ECE/TRANS/WP.29/GRPE/2009/8
31 October 2008

Regulation No. 83

Proposal for draft amendments to Regulation No. 83

Submitted by the expert from the International Organization of Motor Vehicle Manufacturers¹

**Comparison of THC Measurements with heated (Diesel) and non-heated (Otto) FID
(approx. 400 European emission tests from various manufacturers)**

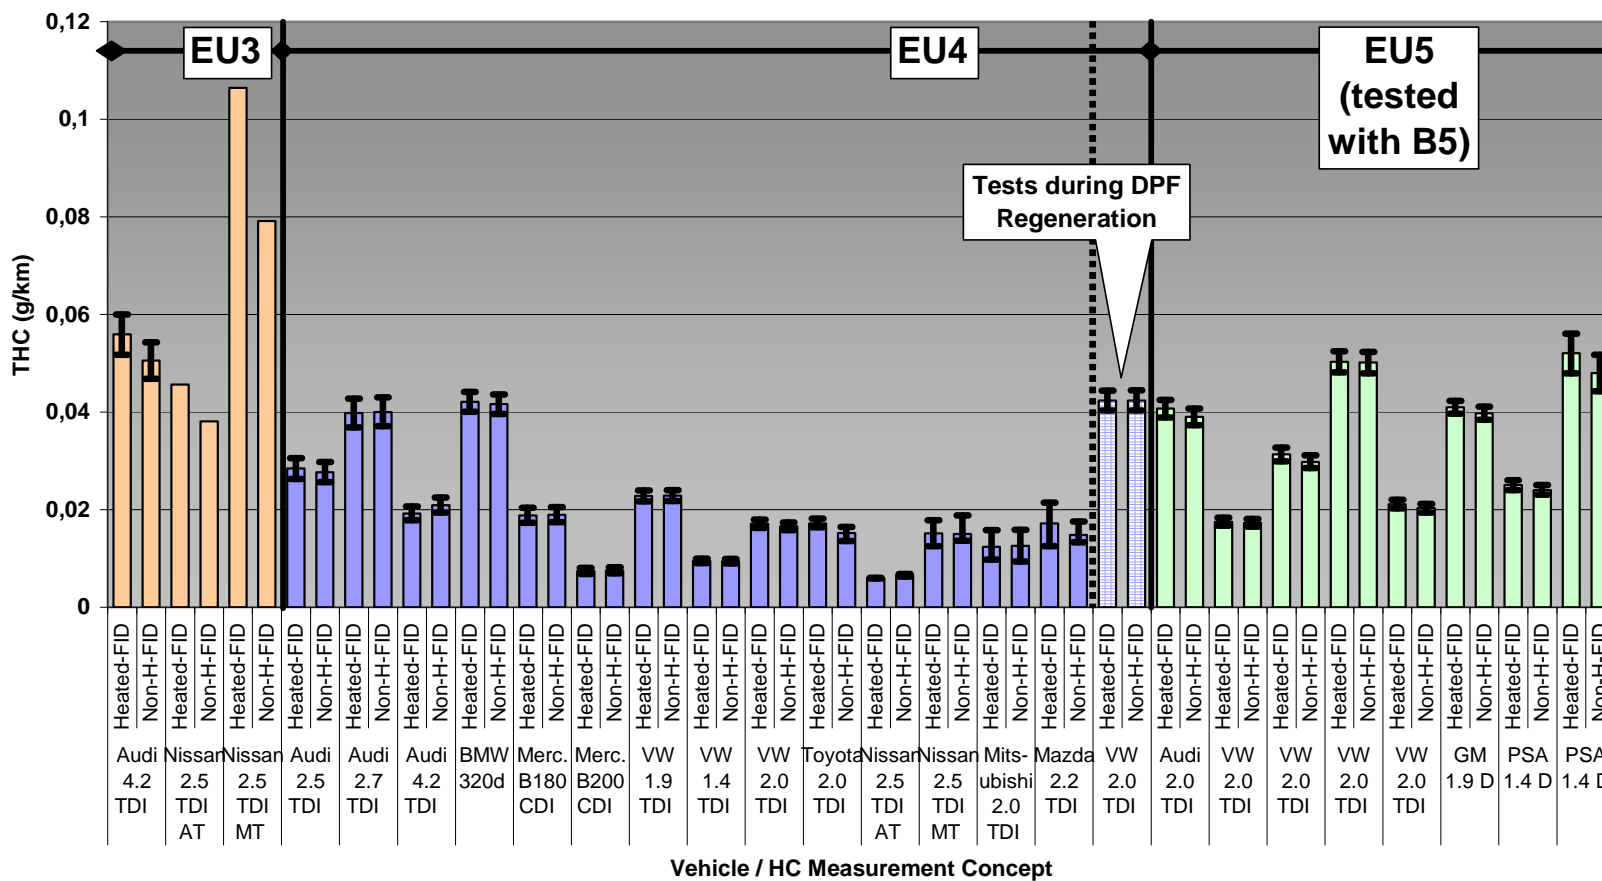
Recent testing of Euro 4 standard diesel engine vehicles has however revealed that the heating of the FID analyser no longer had a significant influence on the emissions results (see summary of about 400 comparative tests). Although of course diesel reference fuel has not changed in terms of volatility between Euro 3 and 4, this can be explained through the effects of two different processes:

Firstly, as the more volatile fuel components are the more combustible, the unburnt components will be disproportionately high in low volatile hydrocarbons. A reduction in the emission limits has then brought about higher injection pressures and other technologies to improve combustion which has naturally reversed this balance.

Secondly, it is the longer chain hydrocarbons that are the less volatile, these long chain molecules are however the more reactive. As the reduction in emissions limits has led to higher catalyst precious metal loadings and earlier light-off times, the long chain hydrocarbons in the exhaust stream have been reduced to insignificant levels similar to those from spark ignition engines.

In view of the above, it is logical to amend Regulation No. 83 to permit non-heated or heated FID devices for all testing.
